PIGALLE

PROJECT: PIGALLE		
DESIGN TITLE: Released for build		
AUTHOR: Laurent	DRAWING NUMBER: Drawing_nr	REV: V3
DATE: 2015-05-12	SIZE: A4	SHEET: 1 of 1

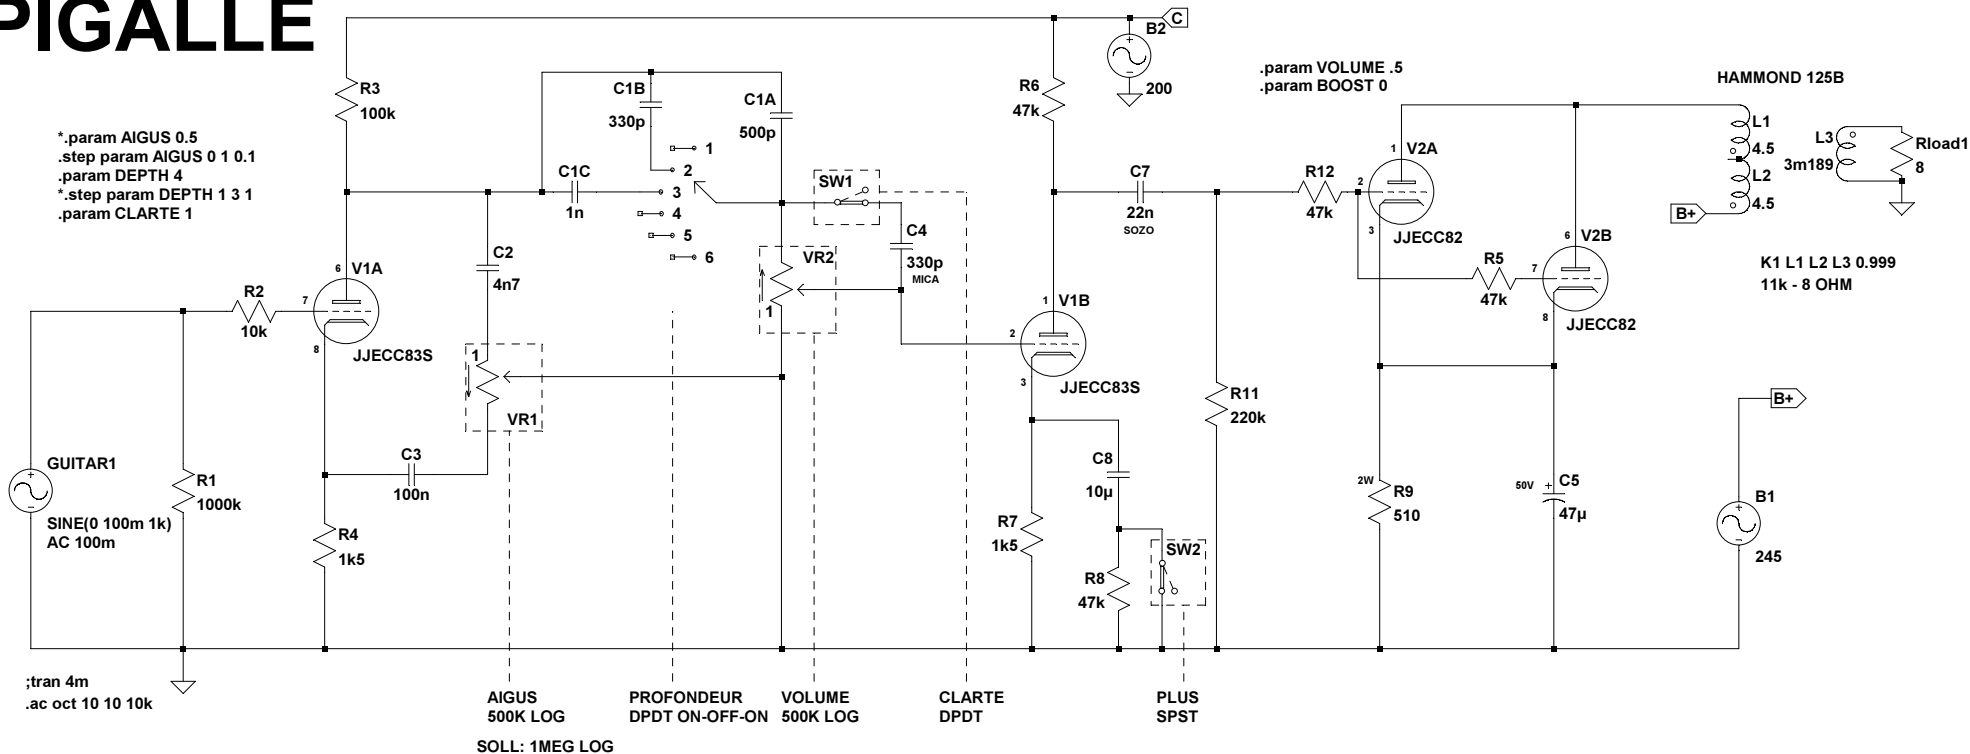
- 1- Simplified PSU
- 2- Only R9 for Rk
- 3- Removed rotary switch (no space)
- 4- Replaced VR1 1M by 500k
- 5- Removed PP/SE switching (risk of mistake too high)
- 6- Only 1 bright cap, not 2
